STAFF RECOMMENDATION
1707 Primrose Avenue
February 19, 2014

Application: Partial demolition; New construction—addition
District: Belmont-Hillsboro Neighborhood Conservation Zoning Overlay
Council District: 18
Map and Parcel Number: 11708005200
Applicant: Van Pond Architect, PLLC
Project Lead: Melissa Baldock, melissa.baldock@nashville.gov

<p>Description of Project: Application is to demolish an existing rear addition and construct a new rear addition that contains an attached garage.</p> <p>Recommendation Summary: Staff recommends approval of the project with the following conditions:</p> <ol style="list-style-type: none"> 1. Staff approve the final window and door selections; 2. A change in material occur on the addition in between the basement level and the first floor. The material for the basement level should be a typical foundation material like split face concrete block; and 3. The HVAC units be placed at the rear of the structure, or on the side façade beyond the midpoint of the house. <p>With these conditions, staff finds that the project meets Sections II.B.1., II.B.2., and III.B.2. of the <i>Belmont-Hillsboro Neighborhood Conservation District: Handbook and Design Guid

Figures 2 & 3. The existing rear addition may be the same as the addition that appears on the 1957-61 Sanborn Map. Nevertheless, it does not contribute to the historic character of the house.

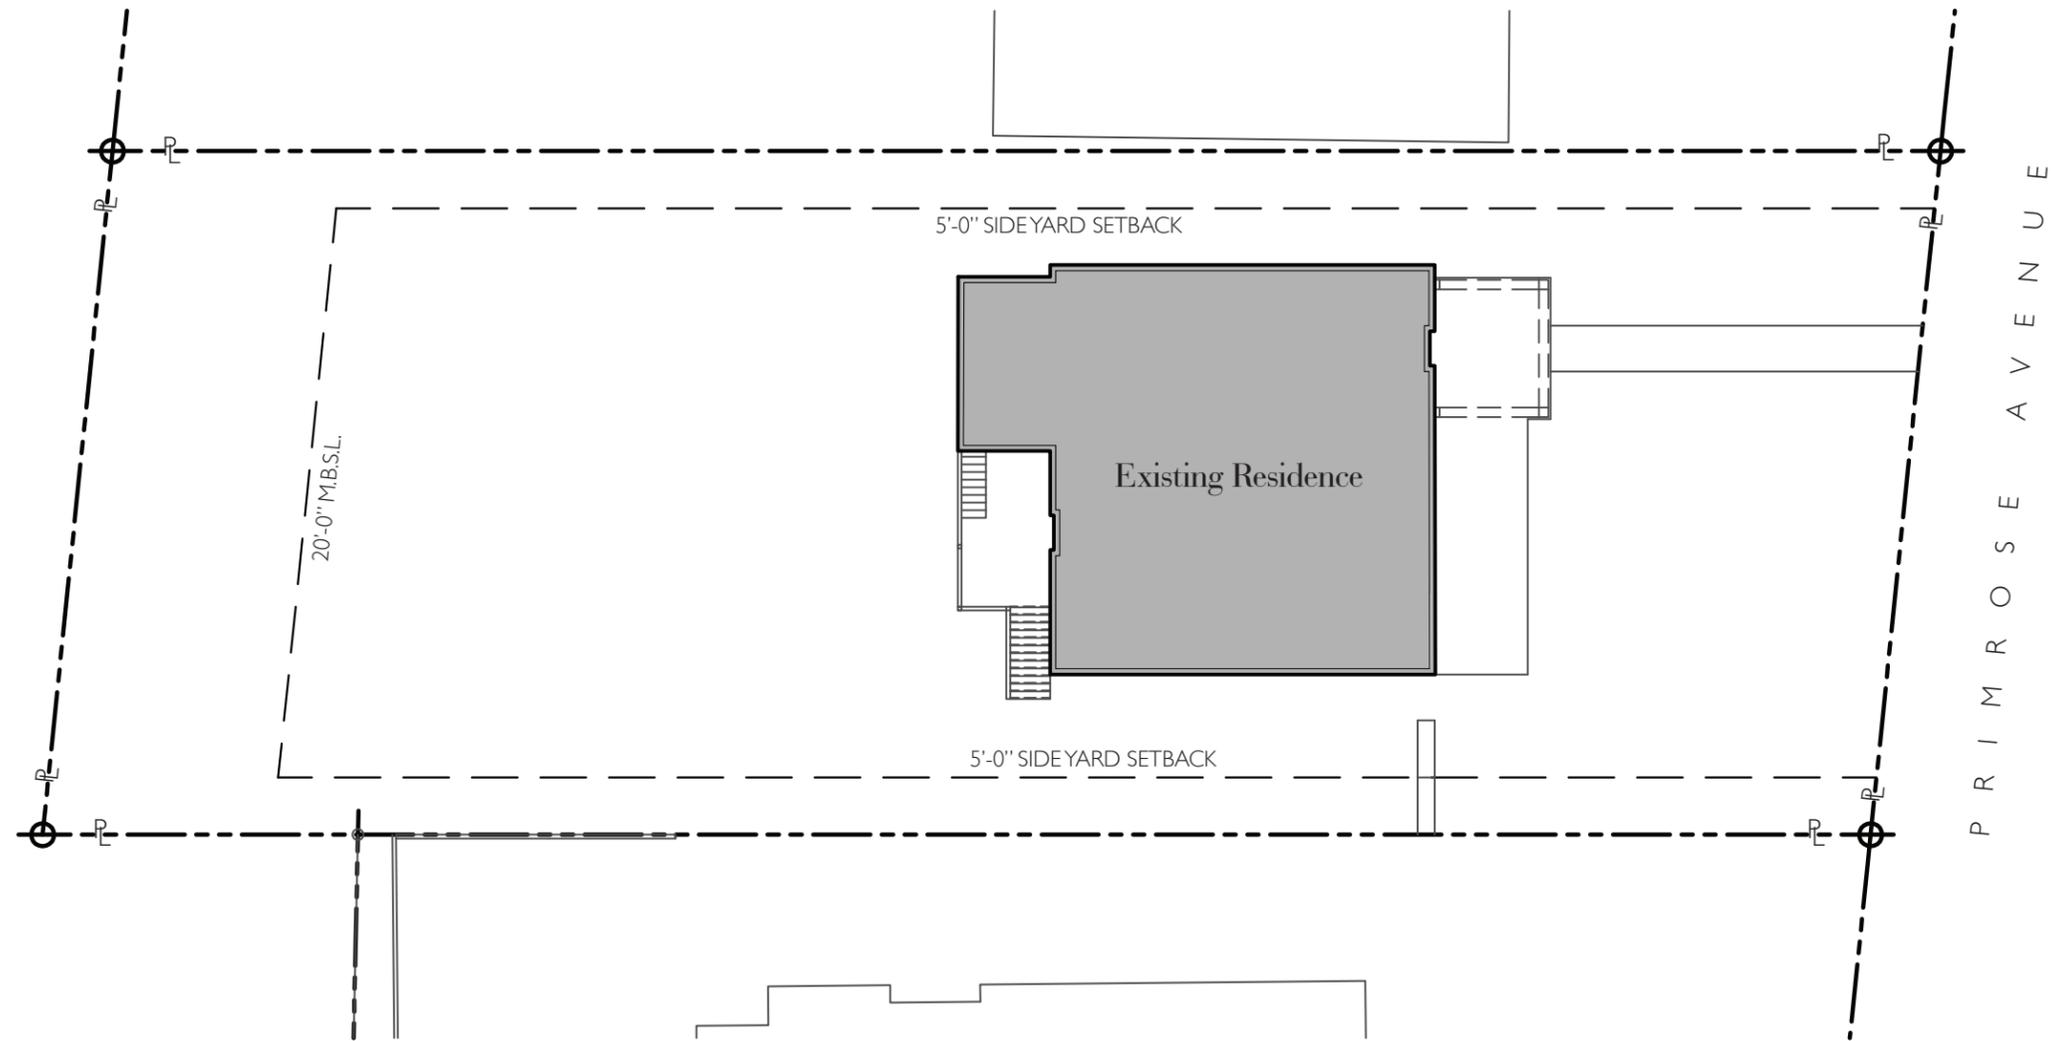
Partial Demolition: The application involves demolishing an existing rear addition to the house (Figure 2). The addition, which includes a two-story porch, may be the same addition that appears on the 1957-61 Sanborn Map (Figure 3). However, staff finds that the existing rear addition, which is not visible from Primrose Avenue, does not contribute to the historic character of the house or the district and that its removal meets the design guidelines.
